# **FINAL** **Initial Study/Mitigated** **Negative Declaration**

## Smith Reservoir Replacement Project

March 2024

Figure 2-6. Phase 1 Site Plan

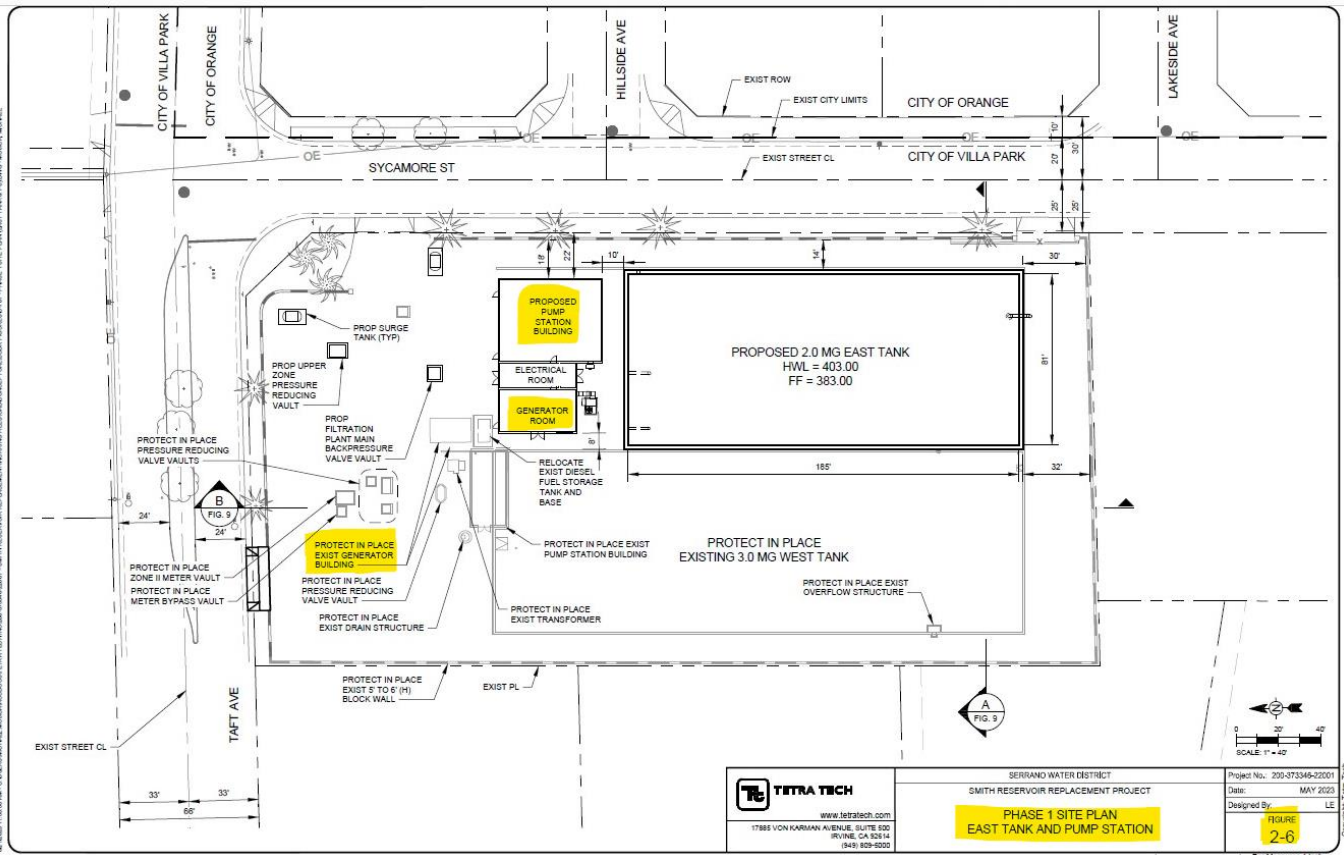
- installation of a new emergency standby generator (diesel fueled) and<sup>11,12</sup>
- construction of a generator room that is in a different location than the existing generator building (see Figure 2-6 below from MND).<sup>13,14</sup>

For the Proposed Project location, South Coast AQMD records show a facility ID # of 107461. Under this ID # is an active South Coast AQMD air permit (permit #F79108) for one internal combustion engine of 764 brake horsepower (BHP), diesel fueled, and driving an emergency generator. The Lead Agency states in the MND that a South Coast AQMD construction permit will be required.<sup>19</sup> From information provided in the MND, however, Staff is unable to determine what type of South Coast AQMD air permit application will be required for the new emergency standby generator proposed to be installed during

The Project involves the replacement of the existing 500 kilowatt (kW) generator with a proposed 800 kW emergency generator for operations. The new generator will be subject to SCAQMD Rule 118.1 (Public Safety Provisions for Stationary Emergency Standby Engines), Regulation II (Permits), and Regulation 13 (New Source Review). The emergency generator will limit the size and operating hours to remain below the Rule 3001 Title V applicability threshold of 100,000 tons per year CO<sub>2</sub>e and 100 tons per year of greenhouse gasses on a mass basis. The project will require air permits for construction and for operation of the replacement emergency generator. Edits will be made as indicated in **Section 3**.

The Project is a replacement project and operational emissions from the proposed project would largely remain the same as existing operations. Analysis will be added to the Final IS/MND for clarification purposes as to the operational emissions associated with the replacement emergency generator, see **Section 3**.
